CORRIGENDUM 1

IEC
62271-102

Part 102: High-voltage alternating current disconnectors and earthing switches

Figure C.2 – Test circuits for electrostatically induced current making and breaking tests

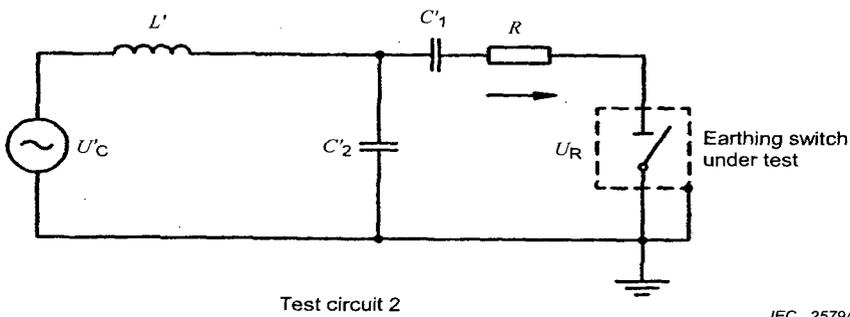
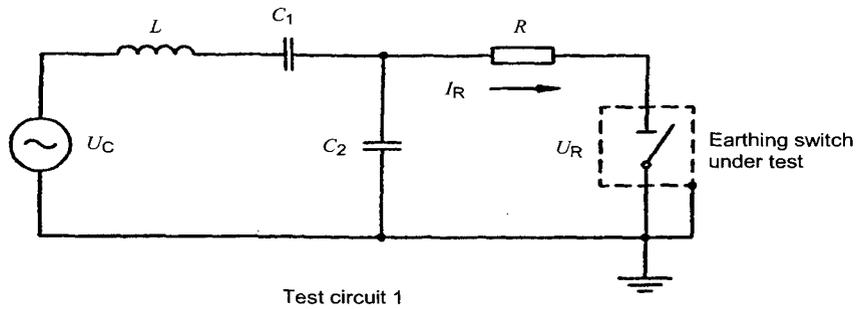
Figure C.2 – Test circuits for electrostatically induced current making and breaking tests

Equation for C_2

Instead of:

$$C_2 = C_1 \times \left[\frac{u_S}{u_i} - 1 \right]$$

read:

$$C_2 = C_1 \times \left[\frac{u_C}{u_R} - 1 \right]$$

Figure F.3 – Test circuit for test duty 2

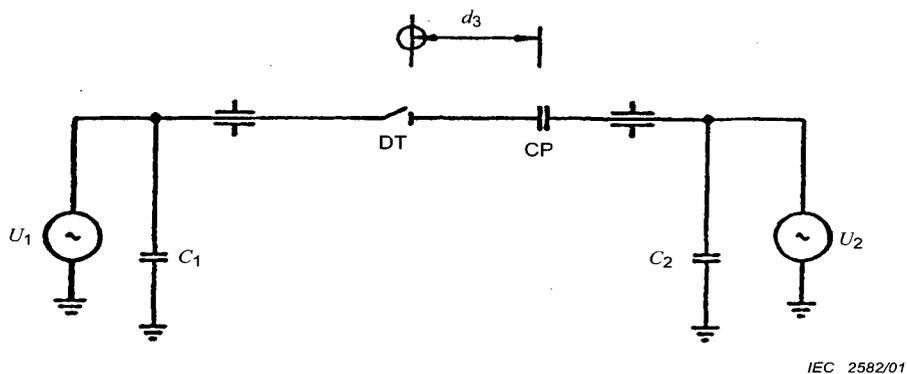
Figure F.3 – Test circuit for test duty 2

Instead of:

C_2

read:

C_L
